To: Open Space and Mountain Parks
Re: Eldorado Mountain/Doudy Draw Trail Study Area Alternatives

BMA Recommendation & Comments on the OSMP Draft Alternative Report

Boulder Mountainbike Alliance Recommended Trail Map

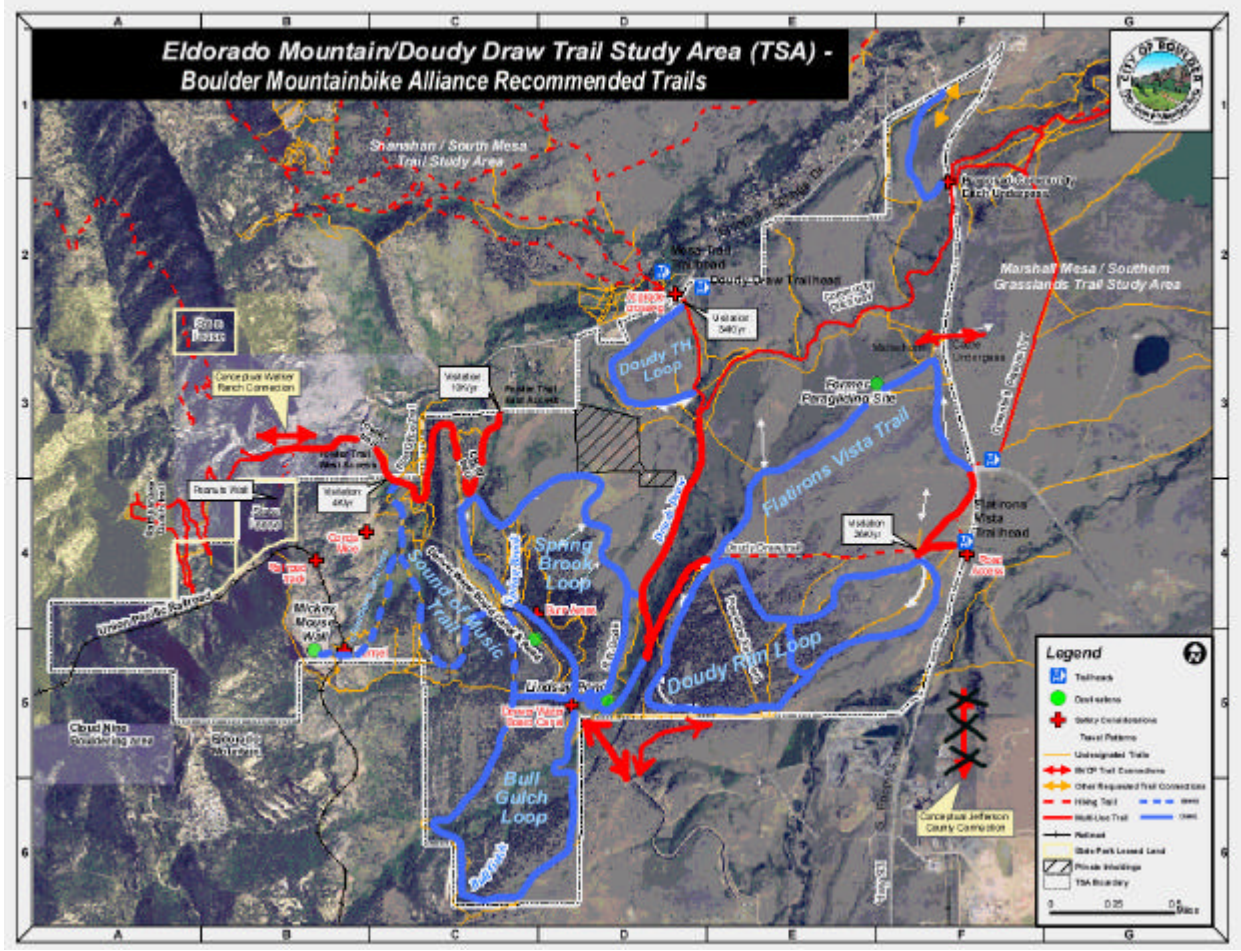
- Doudy Draw Trail
 - The stacked loops southwest of Flatirons Vista trailhead do not use the existing Doudy Draw Trail road alignment. New trail alignments to create flow with climbs and descents are developed to the south of the road. A new trail alignment is designated to the north of the road.

- The section of Doudy Draw Trail that descends from Flatiron Vista to Doudy Draw is extended southwest. The current switchback is too steep. It has grades in excess of 15% and requires too much maintenance. Extending the trail further south allows the switchback to be lower and grade to be eased..

- Doudy Draw Trail is extended south toward Lindsey Pond to a trail junction that connects the Spring Brook loop and the Bull Gulch Loop.
 - The stream crossings on Lower Doudy Draw need to be armored.

- Doudy Rim Loop (**Draft Alternatives Map 1 Location 6**)
 - The drainages in this area offer the potential to create a high quality visitor experience. The map alignments are not exact. The trail sustainability guidelines and local expert advice should be applied to create a fun, challenging, and sustainable trail.

- There is an interior connector trail that links the upper part of this loop with the lower, effectively creating a figure-eight pattern. This significantly increases the variability of the user experience for a small addition in trail mileage.

- Flatirons Vista Trail (**Draft Alternatives Map 1 Location 7**)
 - This trail starts at the Flatirons Vista Trailhead and heads north toward the old Matterhorn site.

- The trail then heads west along the edge of the mesa and flows into the Doudy Draw/Doudy Rim trail junction.
 - There is a promontory spur off this trail to the northwest that affords wonderful views. It is a positive control point and an excellent place for a bench or picnic table.

- A spur at the northeastern edge of the trail utilizes the existing cattle underpass near the old Matterhorn site to connect to the Greenbelt Plateau trails and the City Limits Trailhead east of the Highway.

- Spring Brook Loop (**Draft Alternatives Map 1 Locations 10a & 10b**)
 - This loop meets the existing Doudy Draw Trail at two points: at the south end near Lindsey Pond and below the first stream crossing.

- The trail roughly parallels the Denver Water Board road, but it is important to note that the road is not an appropriate trail. It is wide, flat, often hot, and potentially dangerous. Even if the Denver Water Board grants visitor use of the road, a parallel off-road trail should be designated (**Draft Alternatives Map 1 Location 10b**)

- The northeastern portion of this loop (**Draft Alternatives Map 1 Location 10a**) could utilize portions of the old railroad bed.
- The northwestern point of this trail connects with County Road 67 and to the State Park's Fowler trail (**Draft Alternatives Map 1 Location 14**). This linkage is important for mountain bikers to provide an off road connection into the State Park, on to the Rattlesnake Trail, and to points west (**Draft Alternatives Map 1 Location 12**).

- Bull Gulch Loop (**Draft Alternatives Map 1 Location 18**)
 - This loop follows existing travel patterns and old roads. It minimizes impacts by staying on the outskirts of the property, while providing users with an opportunity to view a remote and beautiful OSMP area.

- In addition to it's inherent value as a high quality visitor experience, this loop is important as a future potential link with public lands in Jefferson County (**Draft Alternatives Map 1 Location 8**). We understand that land acquisition and cooperation with the Denver Water Board may be necessary to make this happen.

- Sound of Music Trail (**Draft Alternatives Map 1 Location 17**)
 - This is a highly desirable trail with outstanding views that visitors will love.
 - The present grades of the upper sections of the existing social trail are excessive. The Trail Suitability Guidelines should be applied to create an appropriate, sustainable alignment. Such an alignment should accommodate both equestrians and mountain bikes.

- Jefferson County Trail Connection (**Draft Alternatives Map 1 Location 8**)
 - The trail plan must include provision for a future connector to Jefferson County Open Space west of Highway 93. This is a critical requirement for mountain bikers. The multi-agency Front Range Trail is a perfect fit for this area.
